UNITED STATES PATENT AND TRADEMARK OFFICE

APPLICATION NO.	FILING DATE	FIRST NAMED INVENTOR	ATTORNEY DOCKET NO.	CONFIRMATION NO.
10/675,260	09/30/2003	Mark Adam Bachman	Bachman 2-9-165-45-32/246	4045
29391	7590	12/21/2004	EXAMINER	
BEUSSE BROWNLEE WOLTER MORA & MAIRE, P. A. 390 NORTH ORANGE AVENUE SUITE 2500 ORLANDO, FL 32801			NGUYEN, THINH T	
			ART UNIT	PAPER NUMBER
			2818

Office Action Summary

DETAILED OFFICE ACTION

FIG. 4(c)

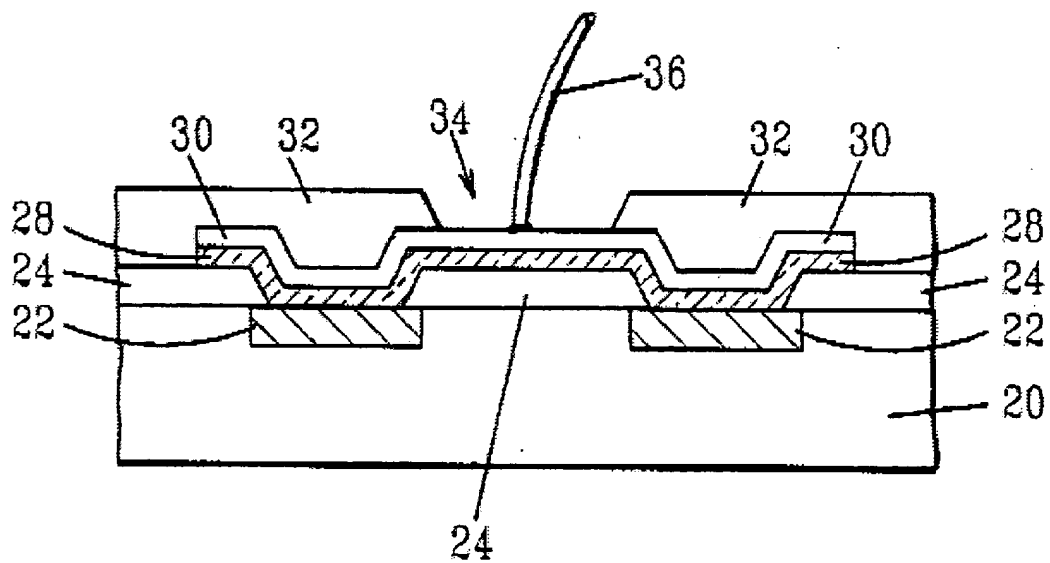
Costrini et al. (the abstract, fig 4© , fig 4(a)) disclose an integrated circuit comprising: a contact pad (fig 4(a) layer 30, column 5 lines 17-30) formed of a metal; a reinforcing layer(layer 28) underlying said contact pad, said reinforcing layer (column 4 lines 64-67, column 5 line 1-7) being formed of a metal different than the metal of the contact pad; at least one metal layer (layer 22) under said reinforcing layer; and at least one dielectric layer(layer 24) disposed under said reinforcing layer.

Costrini et al. (the abstract, fig 4© , fig 4(a),column 5 line 5) disclose an integrated circuit comprising a reinforcing layer that comprises tungsten or tantalum. Those metals are refractory.

To expedite prosecution, The Examiner assume that the applicant claim some sort of pattern. If that is the case, then claim 3 is anticipated by both Costrini et al (in fig 4©) and Pozder et al. (fig. 2)

Costrini et al. (the abstract, fig 4© , fig 4(a),column 5 lines 23-30) disclose an integrated circuit with contact pad wherein the metal the metal of the contact pad is selected from the group comprising aluminum, copper and alloys of aluminum and copper.

Costrini et al. (the abstract, fig 4© , fig 4(a),layer 28, column 5 lines 1-7) disclose an integrated circuit with contact pad wherein the metal of the reinforcing layer is selected from the group comprising titanium, titanium nitride, tungsten, tungsten nitride, nickel, and alloys or combinations thereof.

FIG. 4(a)

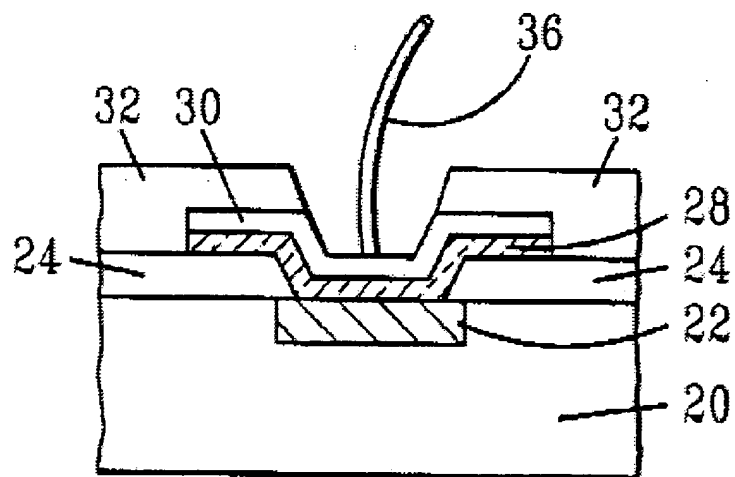
Costrini disclose all the invention except for a different range of thickness for the reinforcing layer 28 : from 100 to 1500 Angstrom or from 10 to 150 nanometer. However, these range still overlaps with applicant claimed range of about 100 to 600 nanometer.

FIG. 2

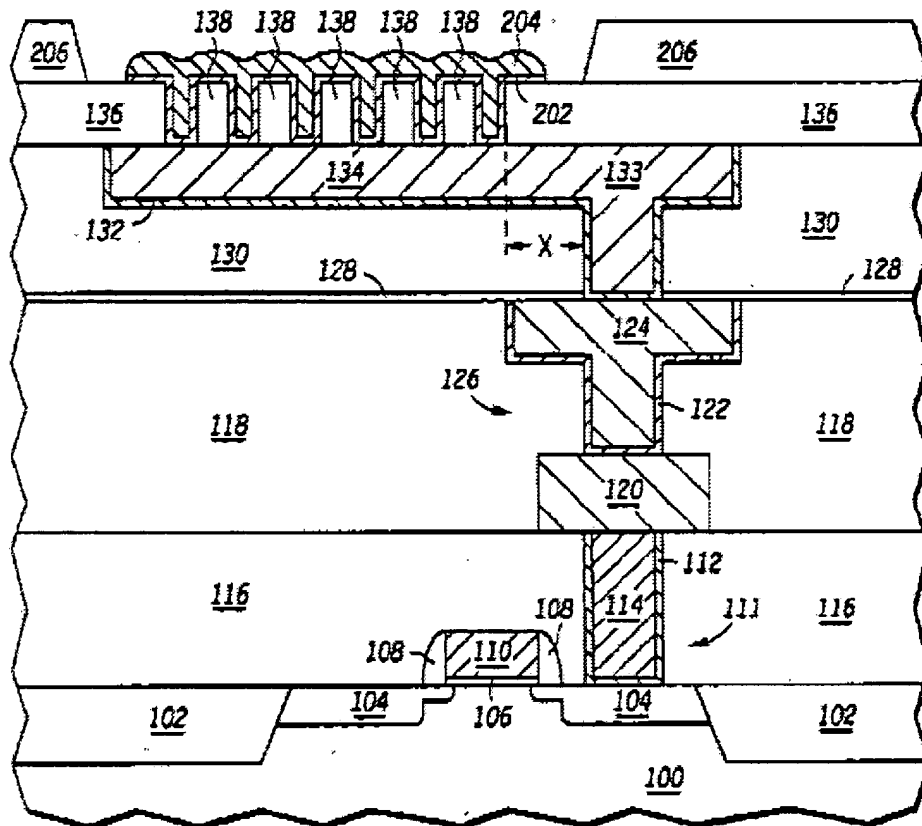
Similarly, Pozder et al. (the abstract, fig 2 layer 204,layer 202,layer 134, layer 136)

disclose the same invention

Similarly, Pozder et al. (the abstract, fig 2 layer 204,layer 202,layer 134, layer 136,column 5 lines 24-26) disclose the same invention

Similarly, Pozder et al. (the abstract, fig 2 layer 204,layer 202,layer 134, layer 136,column 5 lines 29-30) disclose the same invention.

Similarly, Pozder et al. (the abstract, fig 2, layer 202 ,column 5 lines 23-25) disclose the same invention.
